BROWNS FERRY NUCLEAR PLANT (BFN) - UNITS 2 AND 3 - TECHNICAL SPECIFICATIONS (TS) CHANGE TS-418 - RESPONSE TO REQUEST FOR ADDITIONAL INFORMATION SPSB-A.11 REGARDING EXTENDED POWER UPDATE - CREDIT FOR NET POSITIVE SUCTION HEAD (TAC NOS. MC3743 AND MC3744)

ENCLOSURE 1
TENNESSEE VALLEY AUTHORITY (TVA)
BROWNS FERRY NUCLEAR PLANT (BFN) UNITS 2 AND 3
RESPONSE TO NRC REQUEST FOR ADDITIONAL INFORMATION
REGARDING PROPOSED TECHNICAL SPECIFICATION (TS) TS-418
EXTENDED POWER UPRATE - CREDIT FOR NET POSITIVE SUCTION HEAD

NRC REQUEST SPSB-A.11

FIGURE 1
NET POSITIVE SUCTION HEAD REQUIREMENTS FOR DESIGN BASIS LOSS OF COOLANT ACCIDENT – SHORT TERM

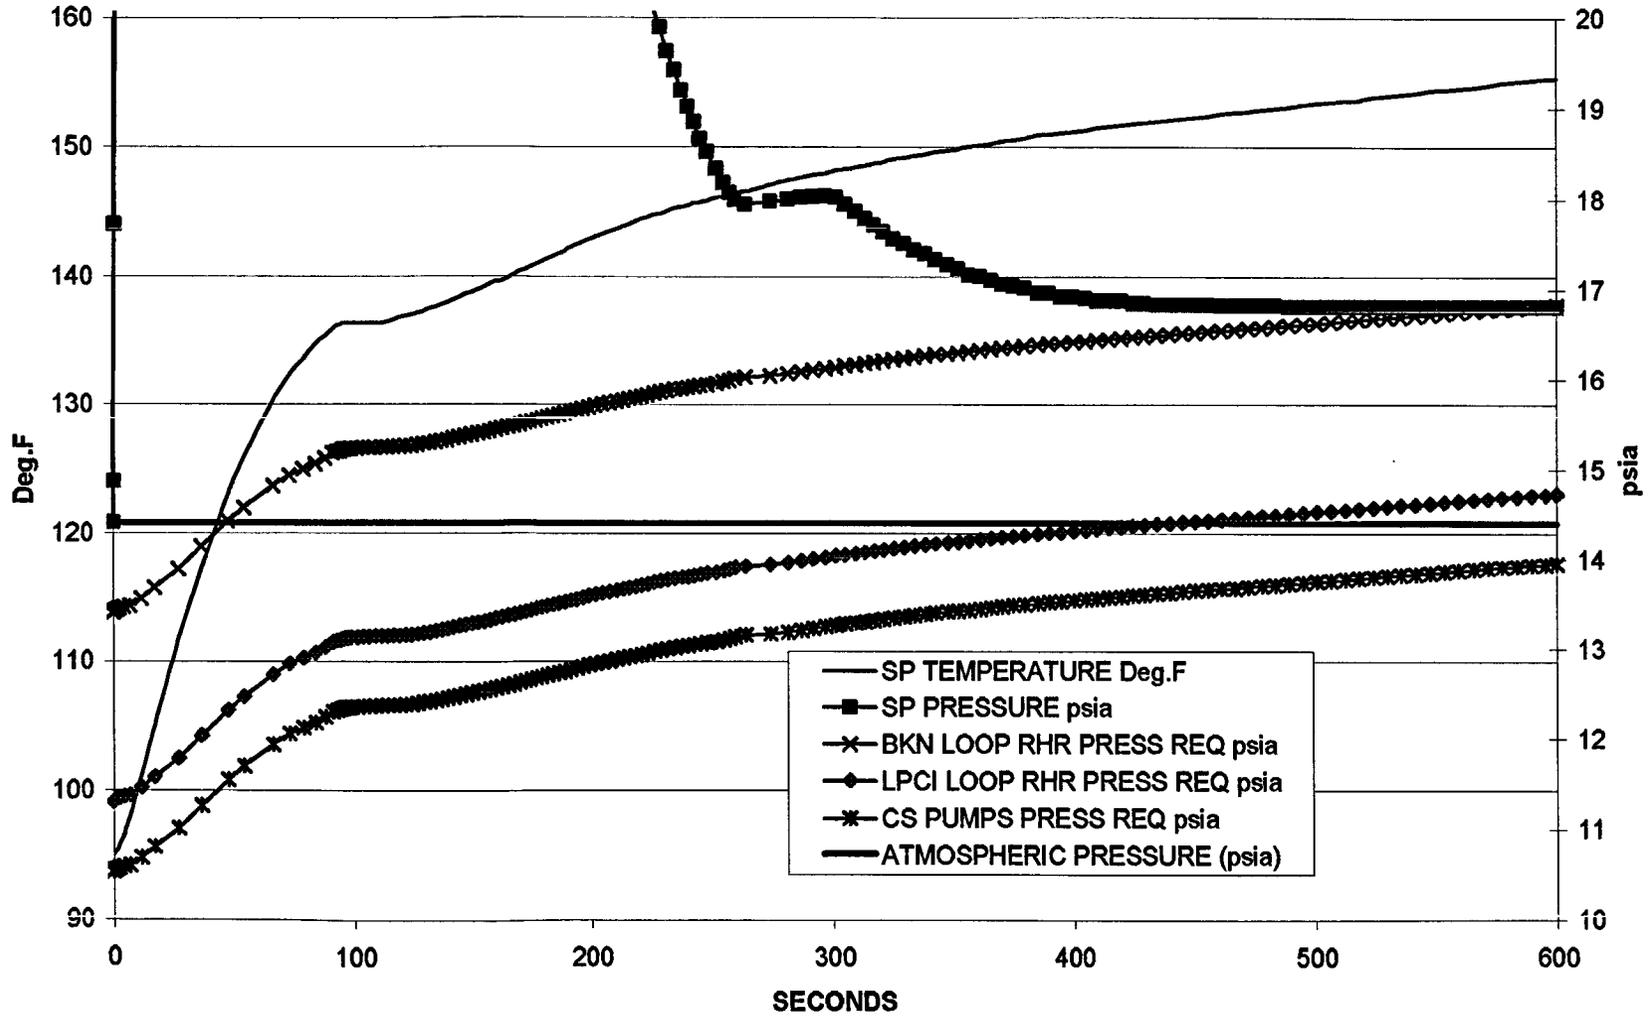
Considering the above discussion, please provide an assessment of the credit for containment accident pressure against the five key principles of risk-informed decision making stated in RG 1.174 and SRP Chapter 19. Specifically, demonstrate that the proposed containment accident pressure credit meets current regulations, is consistent with the defense-in-depth philosophy, maintains sufficient safety margins, results in an increase in core-damage frequency and risk that is small and consistent with the intent of the Commission's Safety Goal Policy Statement, and will be monitored using performance measurement strategies. With respect to the fourth key principle (small increase in risk), provide a quantitative risk assessment that demonstrates that the proposed containment accident pressure credit meets the numerical risk acceptance guidelines in Section 2.2.4 of

The bounding design basis event for determining NPSH margin is a double ended recirculation discharge line break. This event results in maximum suppression pool temperature and maximum total pump flow. The discharge line break is chosen because the low system resistance on the broken line produces the most limiting flow and NPSH for two RHR pumps which are assumed to be pumping into the broken line inside containment. At the beginning of the event, four RHR pumps and four Core Spray pumps start automatically and align to inject to the Reactor Pressure Vessel (RPV). Two RHR pumps inject to the RPV at 10,000 gpm each, two RHR pumps inject through the broken line into the containment at 11,000 gpm each (greater than design flow), and four Core Spray pumps inject to the RPV at 3,125 gpm each. This mode of operation is assumed for 10 minutes consistent with not crediting operator action for 10 minutes. ECCS strainers are assumed to accumulate the maximum equilibrium debris load. During this time suppression pool temperature reaches 155.4°F and only the RHR pumps require credit for COP in order to have sufficient NPSH margin as shown in Figure 1.
